CITY OF AUSTIN – DEVELOPMENT SERVICES DEPARTMENT
SITE PLAN APPLICATION – MASTER COMMENT REPORT

CASE NUMBER: SP-2020-0084D
REVISION #: 00 UPDATE: U2
CASE MANAGER: Ann DeSanctis PHONE #: 512-974-3102

PROJECT NAME: AIM South Lamar C1 Riverside Dr to Barton Springs Road
LOCATION: 204 1/2 S LAMAR BLVD SB

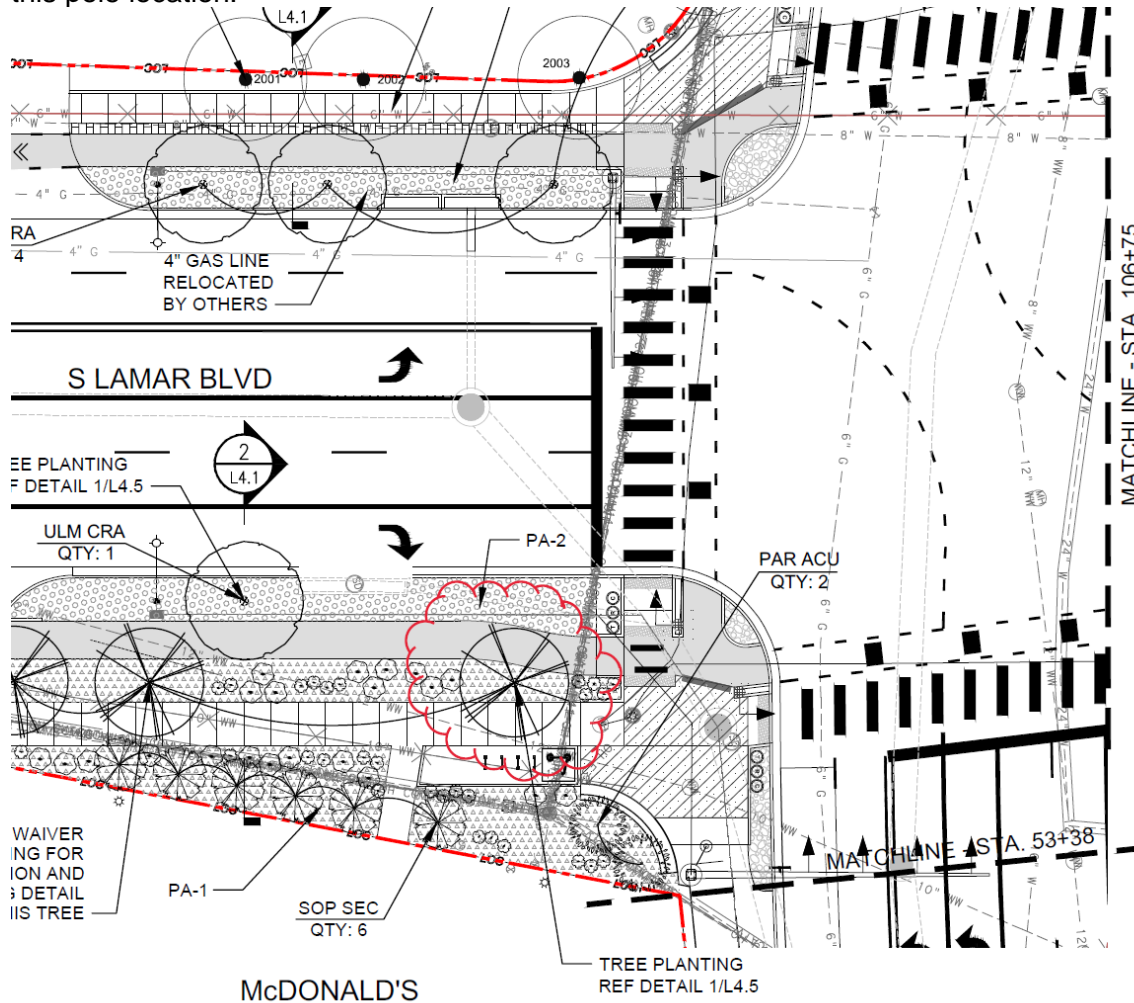
EL 4. Please move highlighted tree further from OH line. AE design notes that tree will limit future access to this pole location.
